Access Compliance Report

(Curb Ramps)

Intersection ID: 27328	Main Street: SPICE_HOLLOW_CT	Cross Street: STANETTE_DR	Location: SW
ADA ID: DCCBAFC45FDF	Ramp Type: PerpDiag	Initial Pass/Fail: Fail	Overall Compliance: No
Severity Score: 21.25			
Codes/Mitigation Info/Possible Solution		Field Measurements/Component Compliance

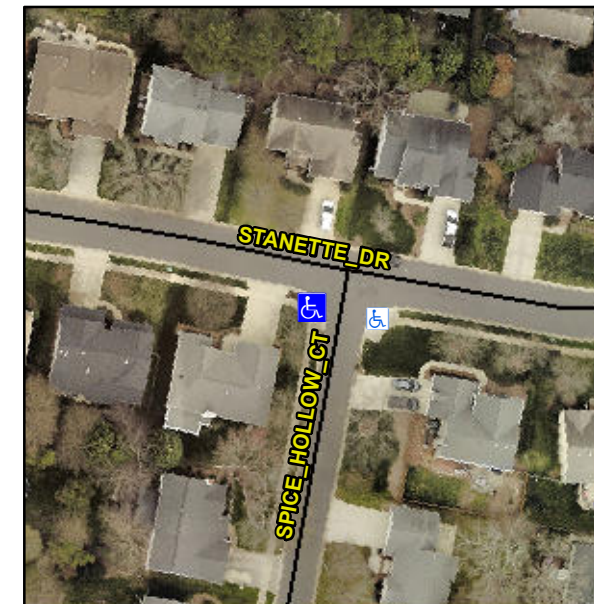
Not Found, R304.5.1, R304.5.3

Compliance	Description	Data	Compliance	Description	Data
N/A	Ramp Length (in)	94.0	Yes	Ramp Slope (%)	5.0
No	Ramp Width (in)	39.5	No	Ramp XSlope (%)	5.3
N/A	Flare Type LT	N/A	N/A	Flare Type RT	N/A
N/A	Flare Slope LT (%)	N/A	N/A	Flare Slope RT (%)	N/A
N/A	Flare Traversable LT?	N/A	N/A	Flare Traversable RT?	N/A
N/A	Landing Length (in)	N/A	N/A	DWS Provided?	N/A
N/A	Landing Width (in)	N/A	N/A	DWS Contrast?	N/A
N/A	Landing Slope (%)	N/A	N/A	DWS Length (in)	N/A
N/A	Landing X Slope (%)	N/A	N/A	DWS Full Width?	N/A
N/A	Landing Curb? (Y/N)	N/A	N/A	DWS Offset (in)	N/A
N/A	Shared Landing?	N/A			
N/A	Gutter Ponding?	N/A	N/A	Gutter Slope (%)	N/A
N/A	Gutter Lip Ht (in)	N/A	N/A	Gutter X Slope (%)	N/A
N/A	Painted X Walk1?	No	N/A	Painted X Walk2?	No
	X Walk 1 Direction	To SE		X Walk 2 Direction	To NE
N/A	X Walk 1 Width (in)	N/A	N/A	X Walk 2 Width (in)	N/A
	X Walk 1 Slope (%)	4.2		X Walk 2 Slope (%)	4.2
	X Walk 1 X Slope (%)	5.3		X Walk 2 X Slope (%)	0.9

Remove & Replace Curb Ramp With Two New Directional Ramps or Equivalent.
